Staff Report
City of Richmond, Virginia

Commission of Architectural Review

3. COA-115910-2022	Final Review	Meeting Date: 8/23/2022
Applicant/Petitioner	Dave Johannas, Johannas Design	
Project Description	Exterior renovations to an existing rear carriage house.	
Project Location		
Address: 1103 W. Franklin Street		
Historic District: W. Franklin Street		
High-Level Details: <p>The applicant proposes to rehabilitate the exterior of a rear carriage house circa 1920.</p> <p>Rehabilitation will include the removal of two garage doors, and the installation of windows and a new garage door to allow for a dwelling unit on the first floor.</p> <p>Applicant must obtain a Special Use Permit post CAR review.</p>		
Staff Recommendation	Approval, with Conditions	
Staff Contact	Alex Dandridge, alex.dandridge@rva.gov , (804) 646-6569	
Previous Reviews	None.	
Conditions for Approval	<ul style="list-style-type: none"> Any replacement glass within the existing windows be clear and not tinted, and that final color specifications be submitted to staff for administrative review. Brick repair or repointing be done using mortar that matches the existing in color and composition as closely as possible, a

Figure 3. Brick damage

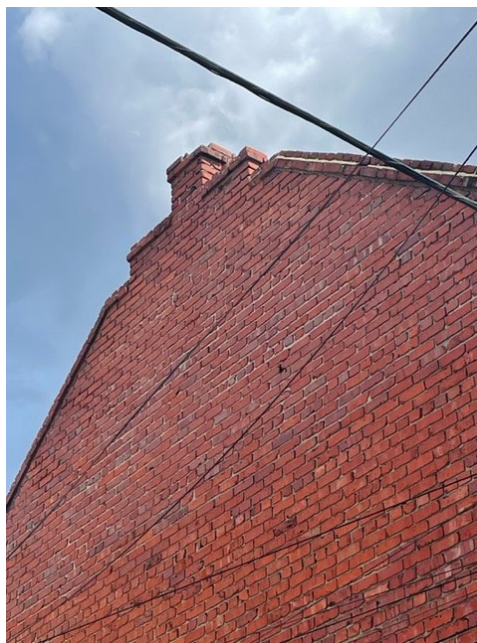
Guideline Reference	Reference Text	Analysis
Building Elements, Windows, pg. 69	<p><i>1. Retain all original windows, and ensure that hardware is in good shape, reusing serviceable window hardware and locks</i></p> <p><i>7. Windows should only be replaced when they are missing or beyond repair. Any reconstruction should be based on physical evidence or photo documentation</i></p>	<p>The applicant proposes to retain and restore all existing windows and doors, with the exception of the two garage doors.</p> <p><u>Staff recommends that any replacement glass within the existing windows be clear and not tinted, and that final color specifications be submitted to staff for administrative review.</u></p> <p>On a site visit staff observed damage to the existing brick on the lower portion of the alley elevation, as well as to the upper parapet. <u>Staff recommends that any brick repair or repointing be done using mortar that matches the existing in color and composition as closely as possible, and that any replacement brick match the original as closely as possible.</u></p>
